Federal	Land	Use, D	esign,	and	Transaction	
	Ap	proval	Subm	issic	n

Société de transport de l'Outaouais (STO) public transit system linking Gatineau's West End to Ottawa – Scenarios under review

Submission: 2020-P218 Page 1 of 6

SCÉNARIO H2a - Tracé et stations

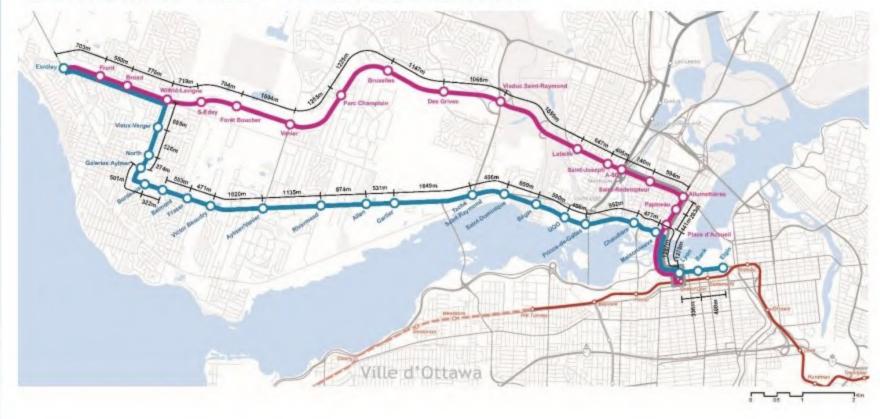
Two of the three scenarios (H1 and H2) would require the widening of certain sections of the Des Allumettières road allowance to make room for the bus or tram facilities, which would directly impact a number of NCC land parcels in Sentier de l'Île Park, in addition to possibly requiring to move the "Papa" public art installation which is currently located at the Des Allumettières / Maisonneuve Blvd. intersection.

These same scenarios would have a similar impact along the Aylmer-/Alexandre Taché corridor, as the necessary road allowance widenings would encroach onto a number of NCC holdings, including a heritage property and building located at 1055 Aylmer Rd. In addition, a transit vehicle garage facility is proposed within the boundaries of the Champlain Golf Course property.

Options à Ottawa

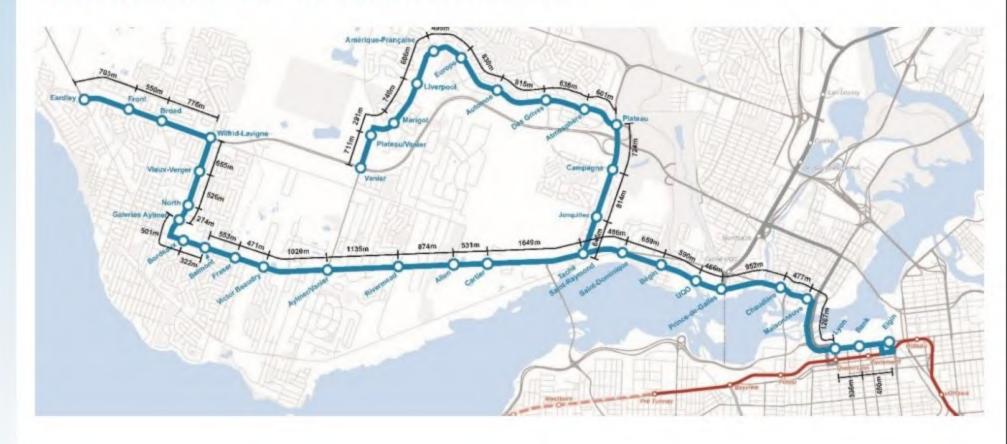
The Wellington Street scenario includes a reserved two-way tram corridor up to Elgin Street, with up to three stations located at the Lyon-Bank and Elgin-Queen intersections. In this section, the tram would operate on batteries only and no overhead wires or structures would be necessary, in keeping with the aesthetic requirements along Confederation Boulevard.

Given the narrowness of the Wellington Street road allowance between Bank and Elgin, this scenario would have impacts, some of them deemed major, on the symbolic and heritage qualities of Confederation Boulevard and Parliament Hill, on vehicular traffic and on the preservation of an existing row of mature trees along Wellington Street.

This scenario would involve the complete redevelopment of Wellington Street, including a 7-meter widening road allowance between Kent and Bay Streets, to be achieved by encroaching onto federally owned properties, as this would be the only possible solution to accommodate all transportation, active mobility and streetscape requirements. Studies have shown that this proposed widening of the roadway allowance would make room for the two-way bicycle path proposed by the NCC and the City of Ottawa and also meet the Confederation Boulevard minimum streetscape requirements. It would, however, require the removal of a number of mature trees and the elimination of existing vehicular access points into the Judicial and Parliamentary precincts.

The first STO station on the Ottawa side would be located in the vicinity of Lyon Street. Given the number of pedestrians needing to cross Wellington Street, a new pedestrian tunnel would be required from the north side of Wellington to the Lyon O-Train Station.

NCC staff have indicated that rather than adding new underground structures at this location, it would be more appropriate to provide an at-grade pedestrian crossing, which would be more in keeping with the Confederation Boulevard design guidelines.

The second station would be located at the Bank Street intersection. Stations in front of Parliament Hill are not recommended for safety and urban design reasons.

The third station would be located on Elgin Street, next to the Queen Street intersection and the National War Memorial. This site would be somewhat challenging, as it is close to a number of buildings with enhanced security requirements. Moving the location of this station further east, along Rideau Street, would have a number of potential benefits, including a possible connection to the existing Rideau station and the possibility of extending the tram route all the way to Alexandra Bridge. Should the Elgin Street site proposed by the STO be retained, design quality will be of paramount importance and any terminal-type installations will be prohibited in order to avoid any negative impacts on the Confederation Boulevard visual landscape.

This scenario proposes a tunnel under Sparks Street, parallel to the O-Train tunnel, with an opening in the rocky outcrop at Commissioner Street. This tunnel scenario would include only two stations, as the underground stops could be spaced and located in conjunction with the existing O-Train stations.

Just like the previous scenario, this option is not without its impact and presents a number of significant technical challenges. However, it has several advantages, especially given Ottawa's Nordic climate. It would be much easier to integrate with the O-Train system and would avoid all the issues associated with the use of Wellington Street.

The tunnel scenario would impact the green spaces and the recreational pathway west of Commissioner Street, along with the entrance to the Cliff Street Heating Plant. At this stage, it is impossible to assess the extent of these anticipated impacts.

The construction costs for the tunnel scenario would be three to five times higher than the Wellington Street scenario. The tunnel scenario scored higher in all other criteria except for the cost.
